Subject: Transmittal of Revision 2 to Service Bulletin Number V2500-NAC-71-0235

V2500 Propulsion System — Nacelle

NACELLE - POWERPLANT – FAN COWL DOORS – APPLICATION OF CAUTION MARKINGS

V2500-NAC-71-0235

Application of Caution Marking
Figure 1 Sheet 1

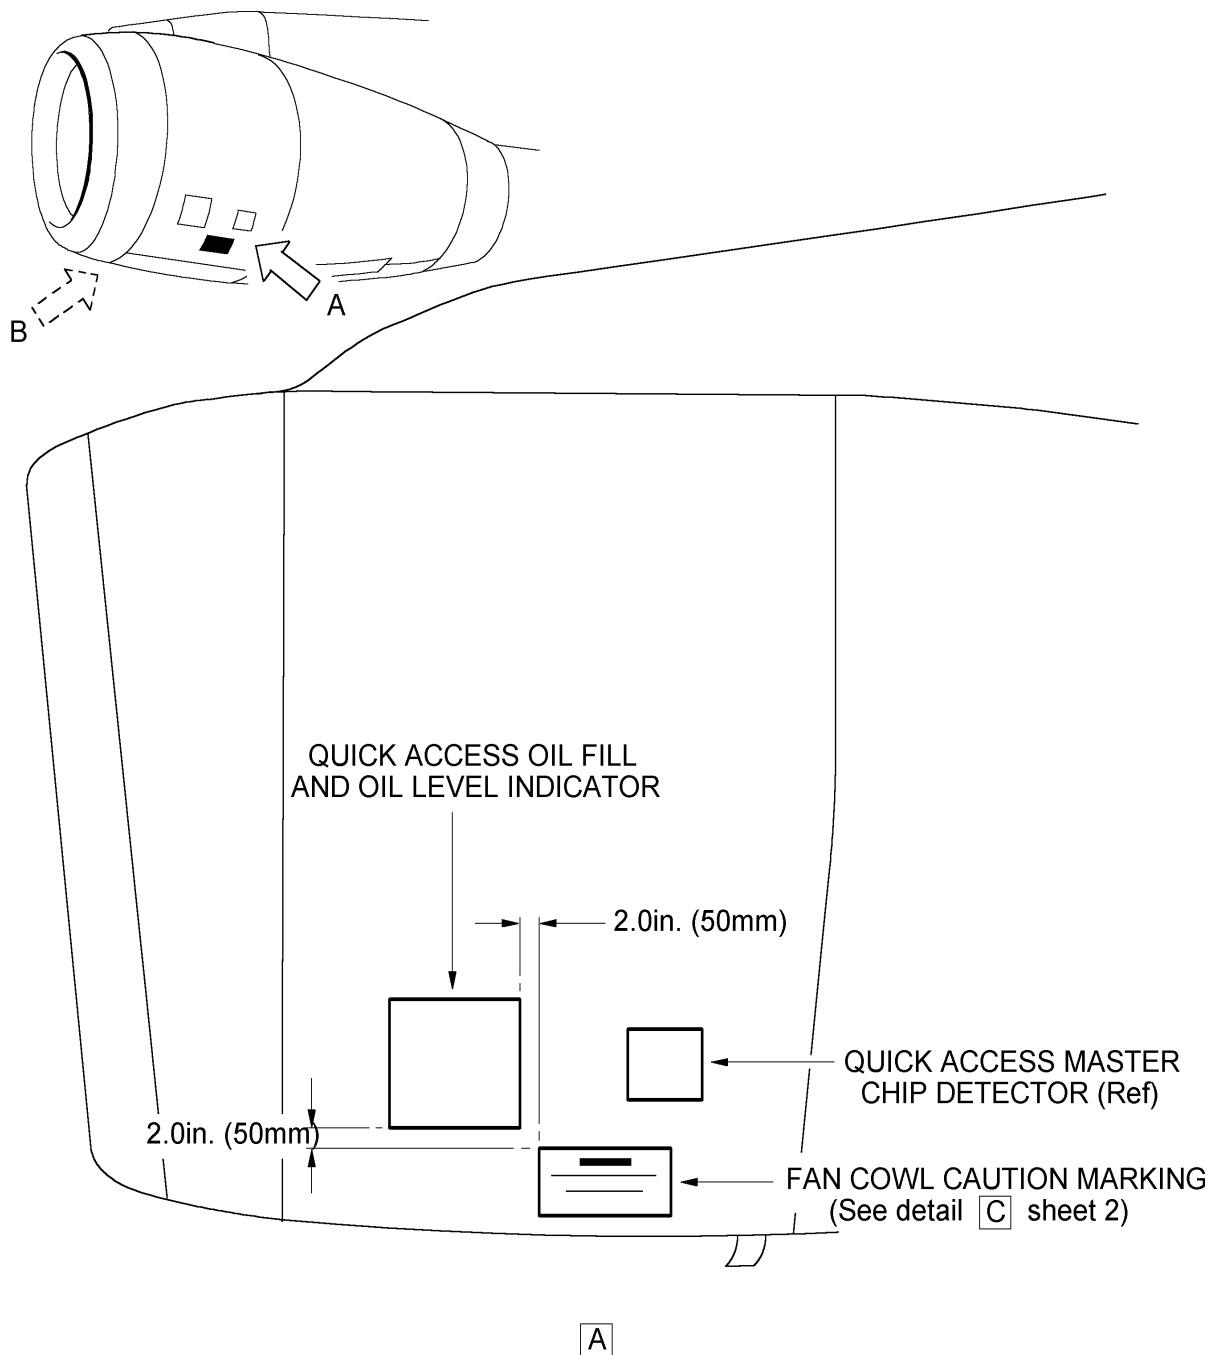
A Fan Cowl Door Latch Decal “MAKE SURE THE FAN COWL DOORS ARE FULLY LATCHED WHEN CLOSED” is added to both left and right doors on both left and right engines. Alternatively the warning may be added using stencils in place of the decals.

- (1) Clean the Fan Cowl Door in the area indicated as 'Fan Cowl Caution Markings' with a clean lint-free cloth (CoMat 02-099) made moist with solvent (CoMat 01-076). Wipe the area dry before the solvent evaporates. (Refer to Figure 1)

- (2) Immerse Label in Adhesive Fixative for fifteen seconds.
- (3) Remove Label from Adhesive Fixative.
- (4) Apply Label to Fan Cowl Door as indicated in figure 1.
- (5) Rub label with a moist sponge to remove any air bubbles.
- (6) After two minutes carefully remove the backing from the Decal.

- (1) Clean the Fan Cowl Door in the area indicated in figure 1 with a clean lint-free cloth (CoMat 02-099) made moist with solvent (CoMat 01-076). Wipe the area dry before the solvent evaporates.

- (3) Use the masking tape to hold the stencil in the correct position (figure 1 sht 1 & 2).

Application of Caution Marking
Figure 2

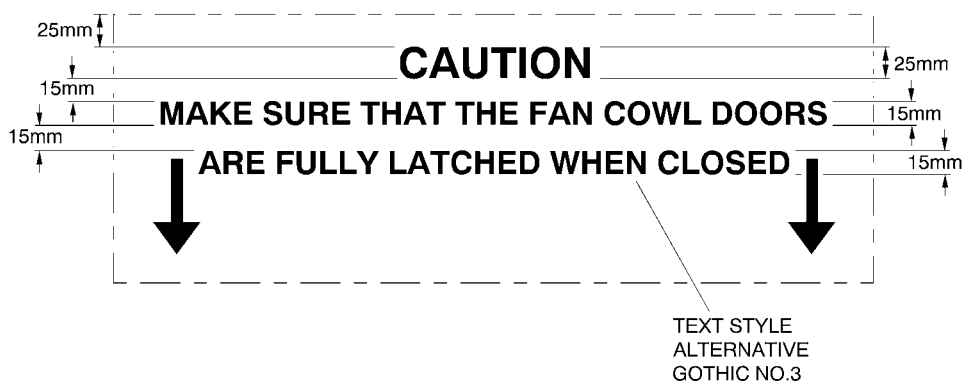
- (2) Prepare the stencil (Ref. Figure 2). The letters are to be No. 3 Alternate-Gothic style. The height of the letters for the word “CAUTION” is to be 25 mm high. All other letters are to be 15mm high.
